G-23 Memo from Mark Davies re Response to Point Wells Urban Center Supplemental Staff Recommendation
PFN: 11 101457 LU

re **Response to Point Wells Urban Center Supplemental Staff Recommendations,
May 9, 2018
MIG|SvR #09038**

date **May 14, 2018**

SECOND ACCESS EXHIBIT

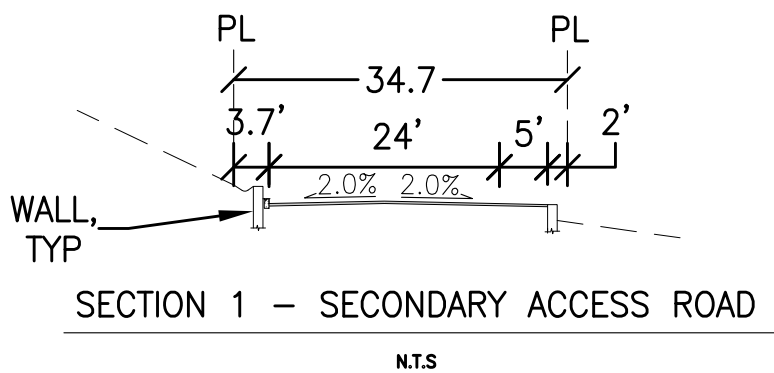
Evaluation of 2018 Resubmittal. The site plan still does not depict the entirety of the second access road to its connection with 116th Avenue West. Instead, the Applicant submitted a separate exhibit showing the secondary access road (Exhibit B-8). This exhibit does include existing contours and proposed finished grades. However, Exhibit B-8 does not depict the property interests that the proposed road would affect or give an adequate depiction of the connection to 116th Ave W. Much of the road would cover a parcel owned by the Applicant; however, this parcel is only 34.7 feet wide in the relevant section (Exhibit D-1), which is less than the road profile shown on Exhibit B-8 of 38.5

feet wide (26' driving area + 5.5' landscaping + 7' sidewalk). Exhibit B-8 is unclear about the location on which parcels the applicant proposes the additional 3.8 feet of road profile. To achieve the necessary road grade, Exhibit B-8 also shows recontouring beyond the parcel owned by the Applicant. This property information is required to demonstrate road feasibility and to ensure any project approval contains pre-conditions to acquire necessary property interests. This lack of information means that the project remains in substantial conflict with compliance with SCC 30.53A.512 Fire Apparatus Access and EDDS 3-01 (B)(5) [2010].

The intent of the exhibit is to show that the second access road can be constructed to meet the SCC 30.53A.512 for roadway grade (min. 15% slope), roadway width (min. 20 ft clear), height clearance (min. 13 ft 6 in) and turning radius (min. 20 ft interior, 40 ft exterior) and materials (asphalt or concrete). The second access to 116th Ave W is included in the stormwater conveyance design and hydraulic model and the pollution generating surface is accounted for in the water quality facility design (calculations are included in the April 24, 2018 targeted drainage report). The second access roadway located within the Town of Woodway is being discussed with both the Town of Woodway and the adjacent private property owners. The access drive is located within the Town of Woodway and will have a separate permit process. The exhibit meets the requirement to show the connections to 116th Ave W and the development. The Town of Woodway typical roadway section is less than shown. We have updated the cross section to indicate removing the curb, planter and sidewalk and adding a walkway adjacent to the roadway which can be constructed within the 34.7' wide parcel. Walls approx. 2 ft to 6 ft will be needed in some areas and both shared access with neighbors or separate access driveway facilities are possible depending on the location. The exhibit indicates compliance with fire access, and walls allow the cross section to remain in the existing property boundary. This project is accepting that project approval contains pre-conditions to acquire necessary temporary easements and other agreements with property owners.
